Eldorado National - California

INSTRUCTION FOR INSPECTION AND REPLACEMENT:

Subject: Safety Recall
NHTSA Recall No. #14V685

Model year 2008 & 2009 Axess, XHF, E-Z Rider, Escort RE-A & Transmark RE.

PART 1 – CHECKING ACCELERATOR PEDAL SERIAL NUMBER

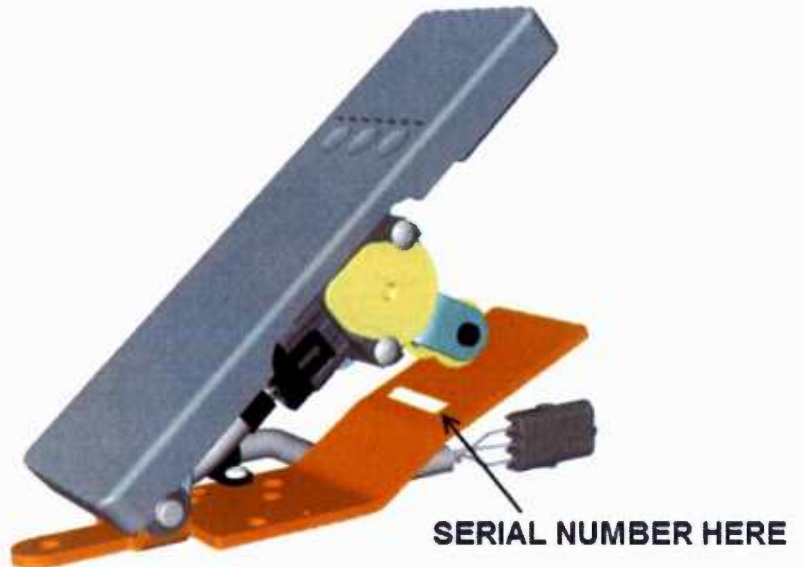
1. Check the serial number on the accelerator pedal assembly.
2. If the accelerator pedal serial number matches with a serial number found in the following list, a replacement of the accelerator pedal is needed. To do so, perform Part 2 of this campaign.
3. If your accelerator pedal serial number is not within the range of affected accelerator pedal, no replacement is needed. No other verification or repair is necessary.

PART 2 –ACCELERATOR PEDAL REPLACEMENT

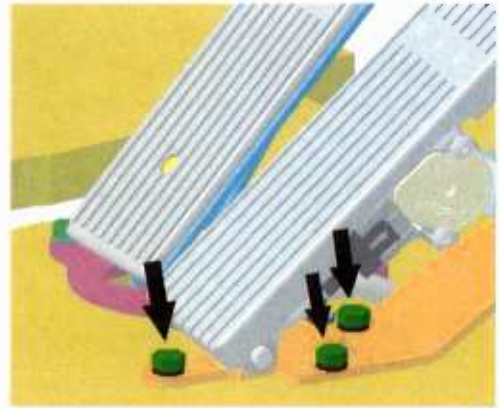
1. Remove accelerator pedal mounting bolts (3x).

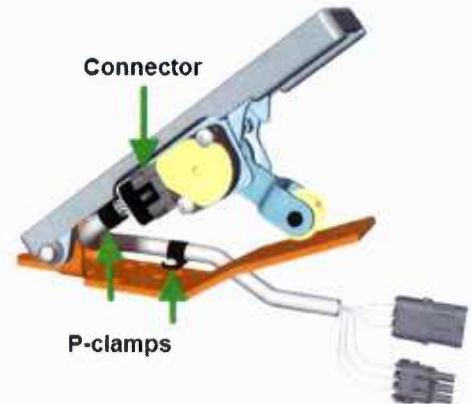
2. Unscrew the electrical harness P-clamps (2x).
3. Unplug the connector from the acceleration pedal. Unless it is in bad condition, reuse the existing harness and connect it to new accelerator pedal.
4. Plug connector to new acceleration pedal. Secure P-clamps onto the new acceleration pedal.
5. Bolt the new accelerator pedal to the floor using the existing hardware.
6. Start the engine. With the parking brake applied and transmission in neutral position (N), test the accelerator pedal for proper functioning.
